PRODUCT/PROCESS CHANGE NOTICE (PCN)

PCN #: SM-0504-03	DATE: April 6, 2005	MEANS OF DISTINGUISHING CHANGED DEVICES:
Product Affected: BF/BFG 100 (Refer Attachment II for the affected part numbers)		<input type="checkbox"/> Product Mark <input type="checkbox"/> Back Mark <input type="checkbox"/> Date Code <input checked="" type="checkbox"/> Other Change in unit quantity per tray
Date Effective: May 2, 2005

ATTACHMENT I - PCN: SM-0504-03

TRAY DRAWING I

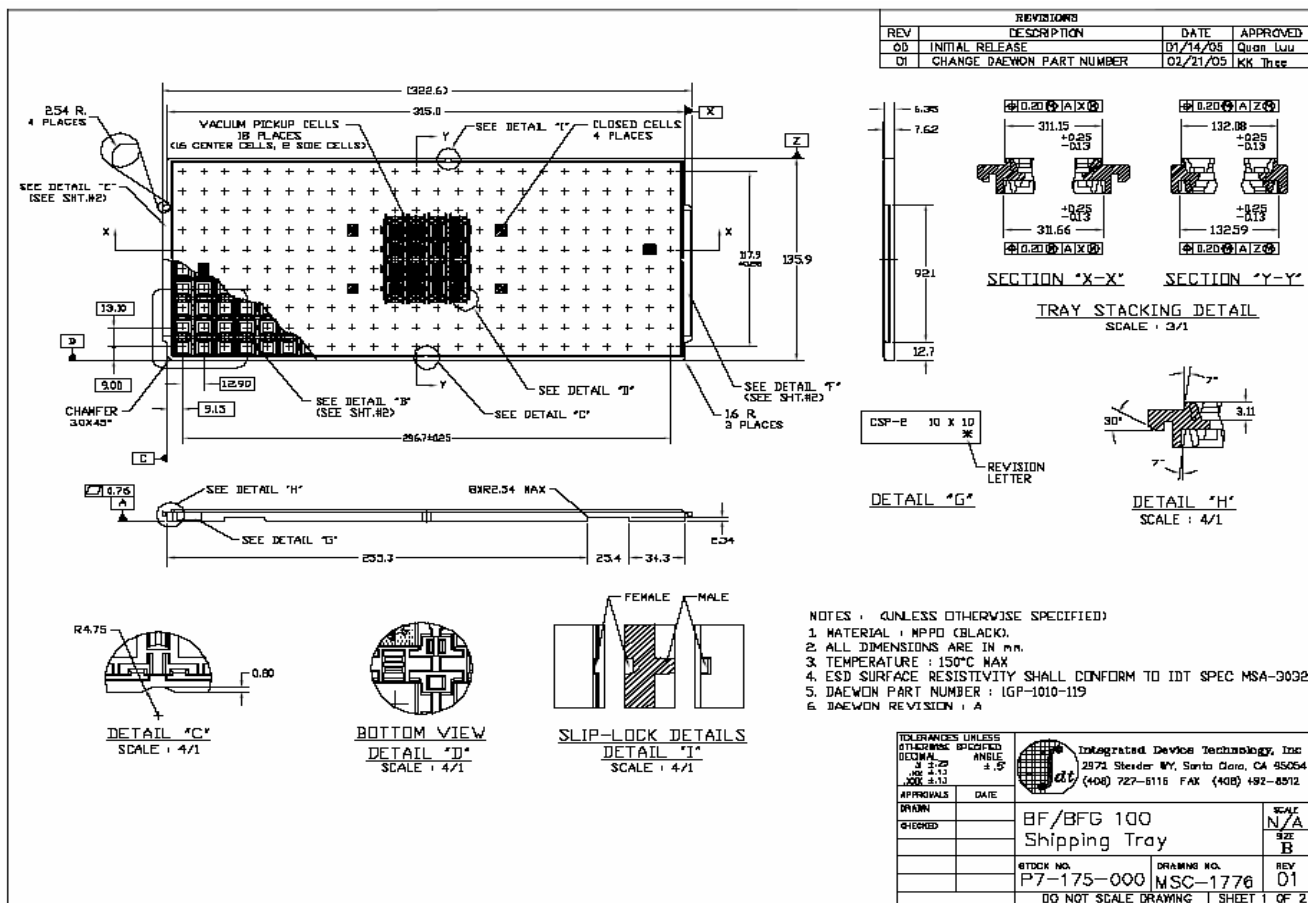
To change new revision of tray with different tray matrix for BF/BFG100. Tray is compliant to JEDEC 95 Standards. Tray size (outside dimensions) will remain the same. New revision of tray provides better pick & place process on equipment.

Description	Current Tray	New Tray
IDT Drawing# :	MSC-1703	MSC-1776
Quantity Per Tray :	250 units	240 units
Pocket Size :	10mm x 10mm	10mm x 10 mm
Tray Matrix :	10 x 25	10 x 24
